Service Information

Category S	Repair Guidance	Ref. No. R017/16C	Page 1 of 7
Coverage <input type="checkbox"/> Distributor only <input checked="" type="checkbox"/> Please inform your dealers		Date Issued February 26, 2016	
Please convey this information to your <input checked="" type="checkbox"/> Warranty Dept. <input checked="" type="checkbox"/> Parts Dept. <input type="checkbox"/> Directing Dept. <input type="checkbox"/> Training Dept. <input type="checkbox"/> General Manager <input checked="" type="checkbox"/> Field Rep.		Date Revised February 1, 2017	
Applicable Model MX-5 (ND) with INNER CLOTH		Applicable Countries or Specifications Worldwide

REVISED

Subject: Convertible Top-Inner Cloth Coming Off Causing Poor Appearance and Obstructing View of Back Window

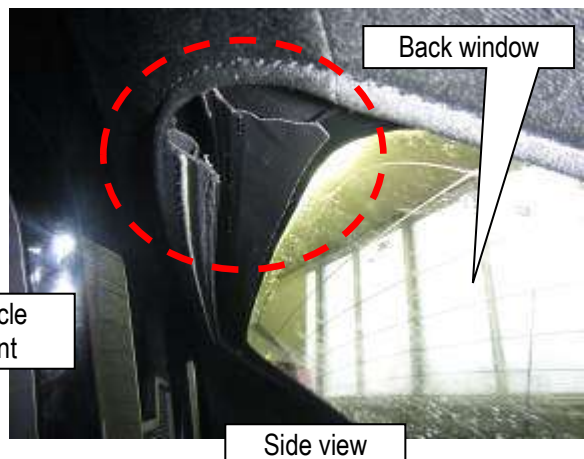
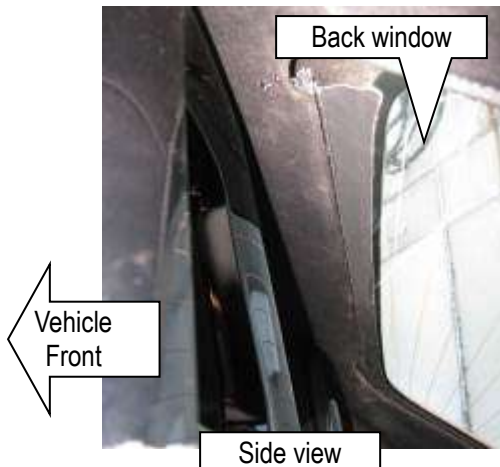
Some vehicles may exhibit a coming off of the inner cloth at the rear end causing poor appearance and obstructing view of the back window.

The coming off occurs when the convertible top is opening and/or closing or by vibration during vehicle driving.

Normal condition

Coming off the inner cloth

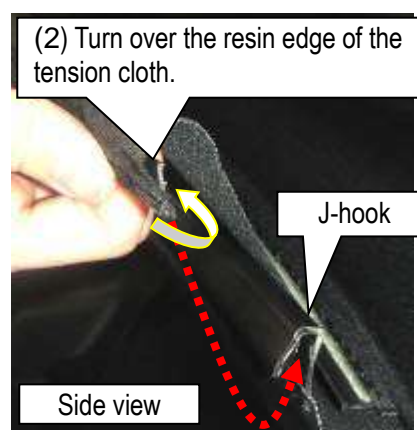
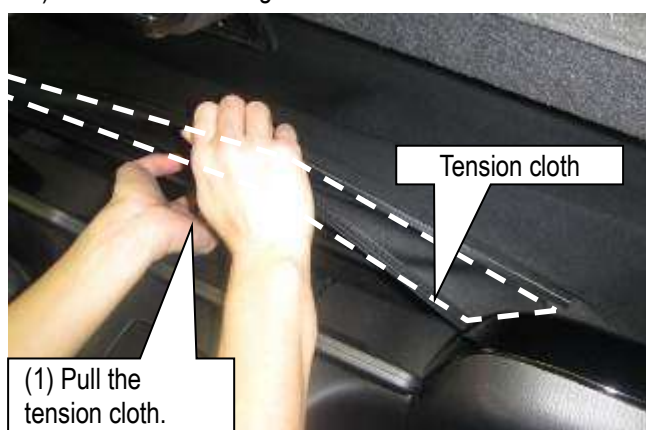
Case B: Vehicle already having installed the clips (top protectors)

Newly order the clips and replace the defective clips with a new one according to the following procedure. The old clips being installed before seem to have less fitting force.

NOTE: Cutting the rib is **NOT** needed for Case B vehicles because the J-hook has a groove to install the ribs easily. Also it is not needed to add glue to the clips.

Case A: Vehicles NOT having installed the clips (top protectors)

Order the new clips (two top protectors) and cut off the ribs.

Add the glue to the inside of the clips and install them to the both sides of the J-hook according to the following repair procedure "2. Install the clips onto both edges of the J-hook".

NOTE: The clip has a rib. Cut the rib before installation to the J-hook.

Since the rib is an obstacle when installing itself to the inner cloth, cut the rib off, and add the adhesive to inside of the clip to stabilize it to prevent of J-hook sliding to the transverse direction.

2. Install the clips onto both edges of the J-hook.

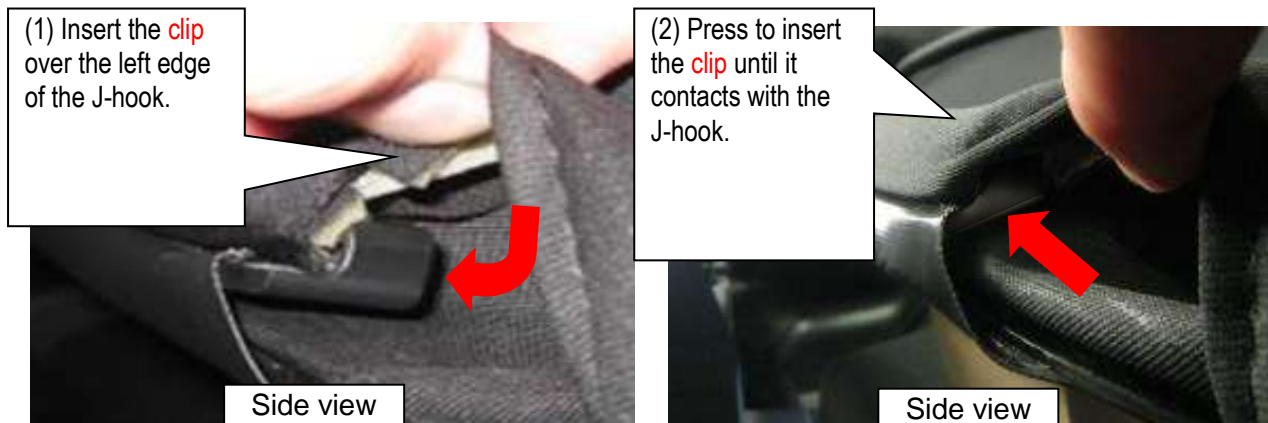
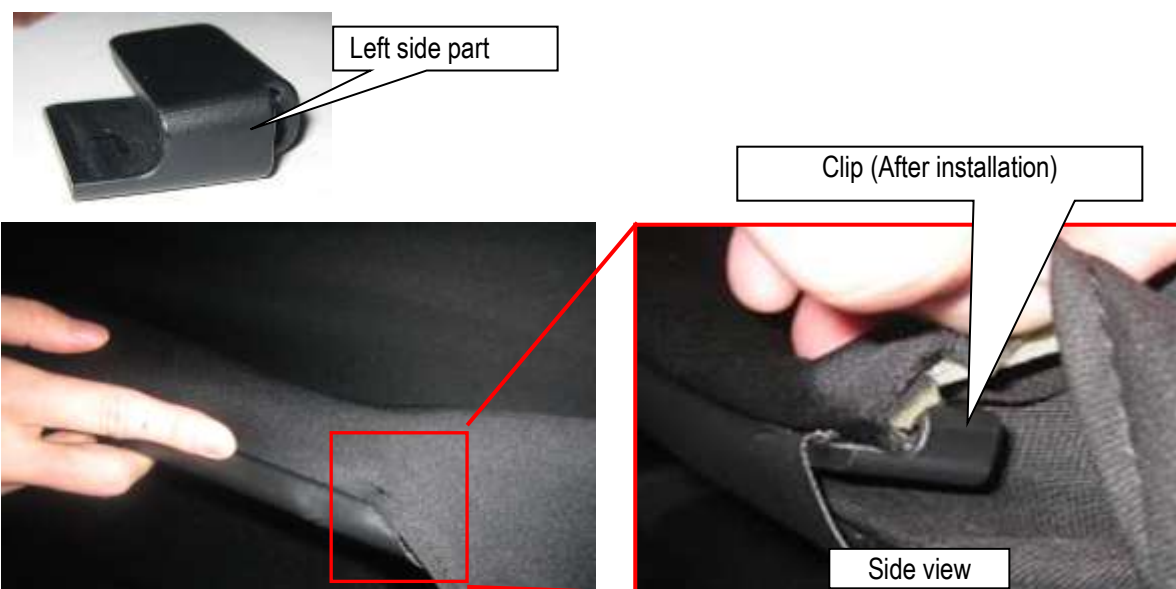
1) Cut off the shaded area of the clip (for both left and right sides).

Apply an appropriate adhesive to the inside of the clip as shown in the illustration.

NOTE: Pictures show the left side.

(see Parts Information) to both edges of the J-hook.

NOTE: Pictures show the left side.

2) Install the clips
